Master Builders Association of Victoria's response to *Better Apartments: Draft Design Standards*

Master Builders has welcomed the opportunity to participate in the *Better Apartments* consultation process, and would like to make a specific comment on the *Draft Design Standards* (the Draft Standards) which was released mid-August.

Submission on behalf of the Building Designers Association of Victoria and Master Builders Association of Victoria prepared by Clause: 1 Planning

FIG. 2.1 - 2.3 SHOWING TYPICAL APARTMENT LAYOUTS FOR EXAMPLE 1 ABOVE

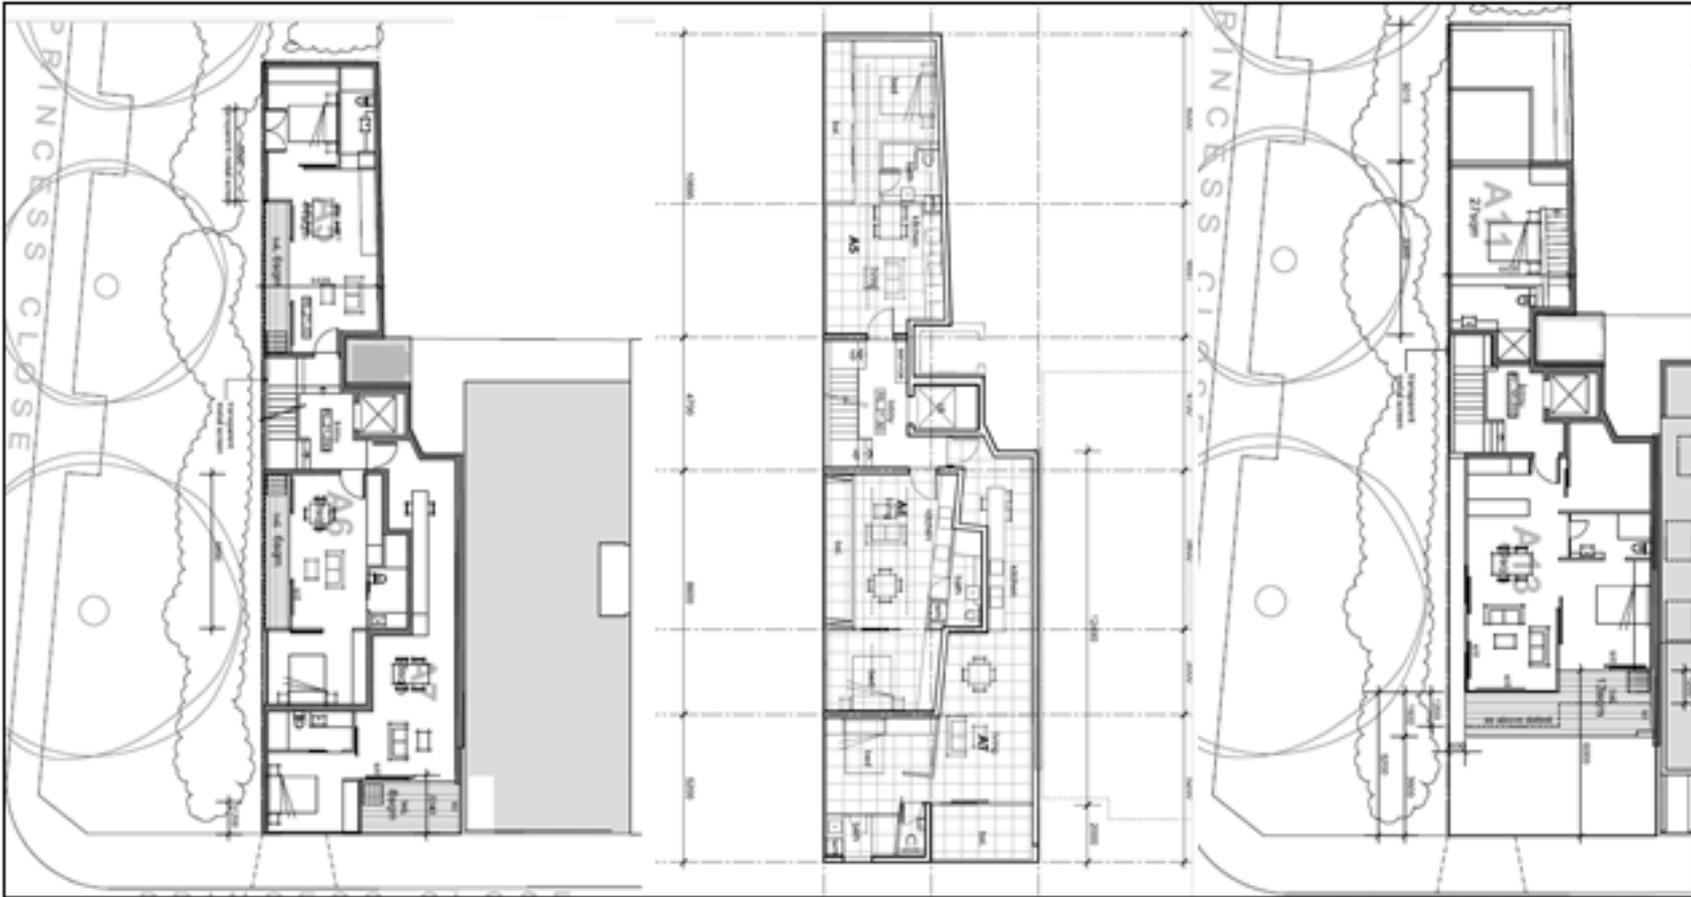
Dwelling type	Minimum storage (m3)									
Studio – 1 bed	6									
2 bed	8									
3 + beds	10									
Noise Impacts	Noise attenuation required to satisfy: <ul style="list-style-type: none"> • Below 35dB(A) for bedrooms, assessed as an LAeq over 8 hours (10pm to 6am). • Below 40dB(A) for living areas, assessed LAeq over 16 hours (6am to 10pm). May dictate how apartments are laid out to avoid external and internal noise sources.	NB. Can't be assessed based on existing information. Will require additional info to be supplied at planning permit stage.								
Energy Efficiency	Cooling loads applied to NatHERS assessment. Three climate zones for Metro Melbourne. More zones to come.	NB Can't be assessed based on existing information.								
Solar access to communal open space	Communal OS should be to the north. 50% should receive direct sunlight for two hours between 0900 – 1500 on 21 June.	No communal open space supplied.

<p>Standard convenient living room, ex utility provisions apply.</p>	Studio – 1 bed	8	2	2 beds	10	2	3 beds +	12	2	
Studio – 1 bed	8	2									
2 beds	10	2									
3 beds +	12	2									
Communal open space	Developments of 20 + dwellings should have COS of 2.5 m ² / dwelling or 100 m ² , whichever is the lesser. Could be a garden/rooftop or a 'party room'. If an outdoor space, above standard applies for solar penetration.	Fewer than 20 apartments so standard does not apply.									
Landscaping	Deep soil areas (ex basements) and tree provision (n) required based on site size. Between 5% - 15% of total site area. Dimensions of 4 – 6 m	Non compliant. Zero provision for planting, 100% site coverage proposed.									
Accessibility	Dwellings 850 mm doorways Adaptable bathrooms/ bedrooms 1200 mm corridors 25% exemption for 2 bedroom dwellings.	Non compliant. Ramp entrance and lift. Some apartments capable of accommodating accessibility requirements subject to reduced living area.									
Dwelling entry and internal circulation	As before. Emphasis on division between residential entries in mixed use developments. Natural light source required in all entries, lift lobbies, stairwells, corridors.	Complies. Glazing (natural light) to lobbies, stairwells, corridors through a perforated metal screen.									
Waste	As before. WMP mandated. Compost encouraged.	Complies. WMP supplied (managed by body corporate). No composting facilities.									
Water Management	WSUD principles emphasised. Purple pipes when available.	Complies. No Raingardens supplied. No purple pipes.

FIG. 3.1 - 3.3 SHOWING TYPICAL APARTMENT LAYOUTS FOR EXAMPLE 2 ABOVE

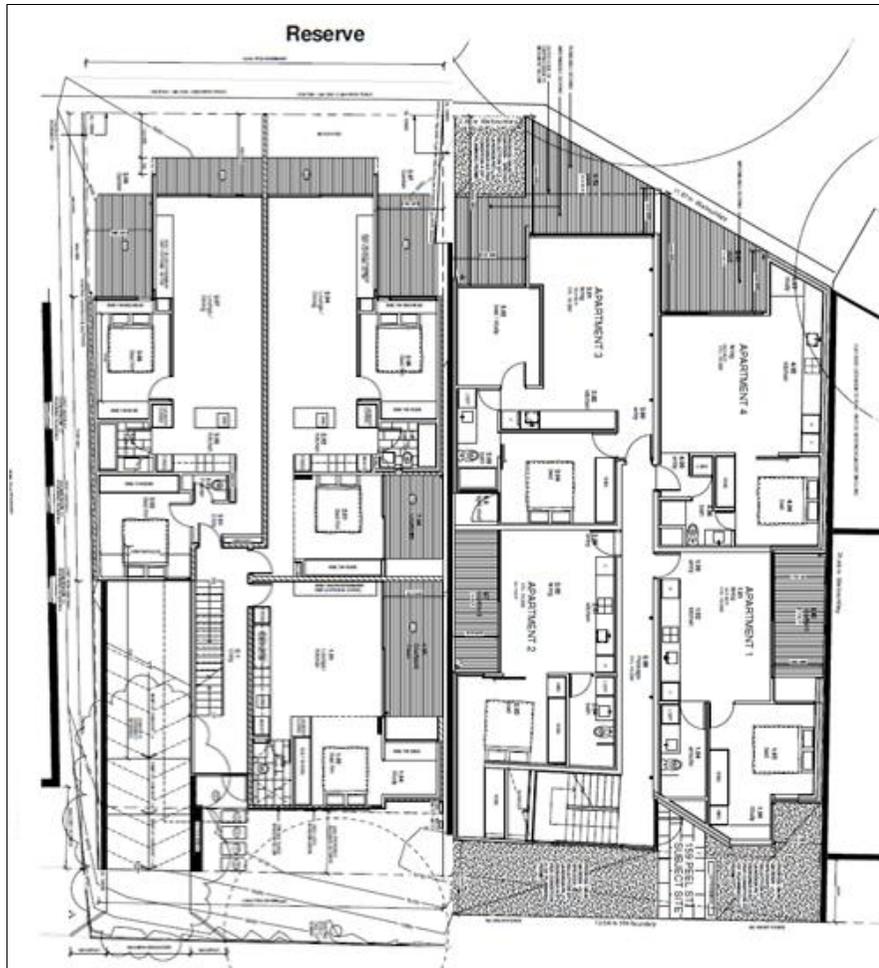
Studio – 1 bed	6									
2 bed	8									
3 + beds	10									
Noise Impacts	Noise attenuation required to satisfy: <ul style="list-style-type: none"> • Below 35dB(A) for bedrooms, assessed as an LAeq over 8 hours (10pm to 6am). • Below 40dB(A) for living areas, assessed LAeq over 16 hours (6am to 10pm). May dictate how apartments are laid out to avoid external and internal noise sources.	NB. Can't be assessed based on existing information. Will require additional info to be supplied at planning permit stage.								
Energy Efficiency	Cooling loads applied to NatHERS assessment. Three climate zones for Metro Melbourne. More zones to come.	NB Can't be assessed based on existing information.								
Solar access to communal open space	Communal OS should be to the north. 50% should receive direct sunlight for two hours between 0900 – 1500 on 21 June.	No communal open space supplied.								
Natural ventilation	60% of units should cross ventilate. Max breeze path 15 m between openable windows and doors. N/A above 35 m + NGL	Partial compliance. Some cross ventilating apartments. Additional opportunities for compliance if light courts could be counted. NB no definition of cross ventilation provided.

<p>Standard convenient living room, ex utility provisions apply.</p>	Studio – 1 bed	8	2	2 beds	10	2	3 beds +	12	2	
Studio – 1 bed	8	2									
2 beds	10	2									
3 beds +	12	2									
Communal open space	Developments of 20 + dwellings should have COS of 2.5 m ² / dwelling or 100 m ² , whichever is the lesser. Could be a garden/rooftop or a 'party room'. If an outdoor space, above standard applies for solar penetration.	Fewer than 20 apartments so standard does not apply.									
Landscaping	Deep soil areas (ex basements) and tree provision (n) required based on site size. Between 5% - 15% of total site area. Dimensions of 4 – 6 m	Non compliant. Deep soil areas provided (ex basement) 2.5 m wide. Denoted as containing rain gardens to serve WSUD principles as opposed to tree planting compliant with this standard. NB safety, illegal dumping. Could double as communal open space?									
Accessibility	Dwellings 850 mm doorways Adaptable bathrooms/ bedrooms 1200 mm corridors 25% exemption for 2 bedroom dwellings.	Non compliant. No lift. Stairs from all levels. Some apartments capable of accommodating accessibility requirements subject to reduced living area.									
Dwelling entry and internal circulation	As before. Emphasis on division between residential entries in mixed use developments. Natural light source required in all entries, lift lobbies, stairwells, corridors.	Complies. Glazing (natural light) to lobbies, stairwells, corridors.									
Waste	As before. WMP mandated. Compost encouraged.	Complies. WMP supplied (managed by body corporate). No composting facilities.									
Water Management	WSUD principles emphasised. Purple pipes when available.	Complies. Raingardens supplied. No purple pipes.

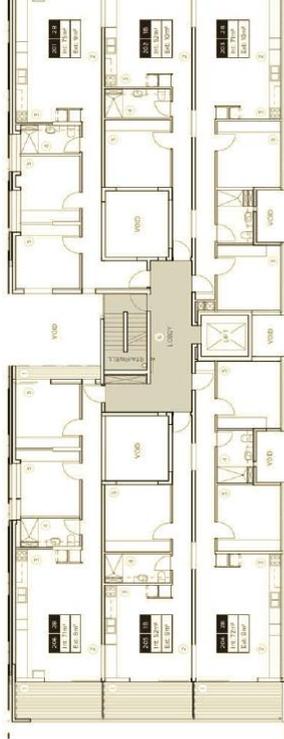
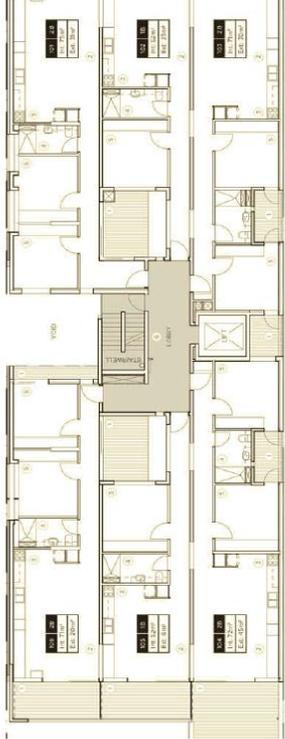
Can be external or internal. Examples show storage in core areas or in typical basement cages	Dwelling type	Minimum storage (m3)	Studio – 1 bed	6	2 bed	8	3 + beds	10	Compliant. Plentiful ground floor storage provided.
Dwelling type	Minimum storage (m3)									
Studio – 1 bed	6									
2 bed	8									
3 + beds	10									
Noise Impacts	Noise attenuation required to satisfy: <ul style="list-style-type: none"> • Below 35dB(A) for bedrooms, assessed as an LAeq over 8 hours (10pm to 6am). • Below 40dB(A) for living areas, assessed LAeq over 16 hours (6am to 10pm). May dictate how apartments are laid out to avoid external and internal noise sources.	NB. Can't be assessed based on existing information. Will require additional info to be supplied at planning permit stage.								
Energy Efficiency	Cooling loads applied to NatHERS assessment. Three climate zones for Metro Melbourne. More zones to come.	NB Can't be assessed based on existing information.								
Solar access to communal open space	Communal OS should be to the north. 50% should receive direct sunlight for two hours between 0900 – 1500 on 21 June.	Summer and winter rooftop terraces provided. South of plant, solar penetration may be impeded but likely to comply.								
Natural ventilation	60% of units should cross ventilate. Max breeze path 15 m between openable windows and doors. N/A above 35 m + NGL	Partial compliance. Few cross ventilating apartments. NB no definition of cross ventilation provided.								
POS	GF apartments: 25 m2 x 3 m Podium / patio: 15 m2 x 3 m Balconies:	Non compliant. Some apartments supplied with less than 8 m2 ~5 – 6 sqm. Dimensions not noted on plan.

Type	Area m2	Dimension m		
	Studio – 1 bed	8	2		
	2 beds	10	2		
	3 beds +	12	2		
	Standard convenient living room, ex utility provisions apply.				
Communal open space	Developments of 20 + dwellings should have COS of 2.5 m2 / dwelling or 100 m2, whichever is the lesser. Could be a garden/rooftop or a 'party room'. If an outdoor space, above standard applies for solar penetration.			67.5 sqm of communal open space required. Supplied via a rooftop terrace featuring bbq facilities. Communal laundry.	
Landscaping	Deep soil areas (ex basements) and tree provision (n) required based on site size. Between 5% - 15% of total site area. Dimensions of 4 – 6 m			Non compliant. Zero provision for planting, 100% site coverage proposed.	
Accessibility	Dwellings 850 mm doorways Adaptable bathrooms/ bedrooms 1200 mm corridors 25% exemption for 2 bedroom dwellings.			Non compliant. Ramp entrance and lift. Some apartments capable of accommodating accessibility requirements subject to reduced living area.

Dwelling entry and internal circulation	As before. Emphasis on division between residential entries in mixed use developments. Natural light source required in all entries, lift lobbies, stairwells, corridors.			Complies. Glazing (natural light) to lobbies, stairwells, corridors through voids.	
Waste	As before. WMP mandated. Compost encouraged.			Unable to assess.	
Water Management	WSUD principles emphasised. Purple pipes when available.			Unable to assess.
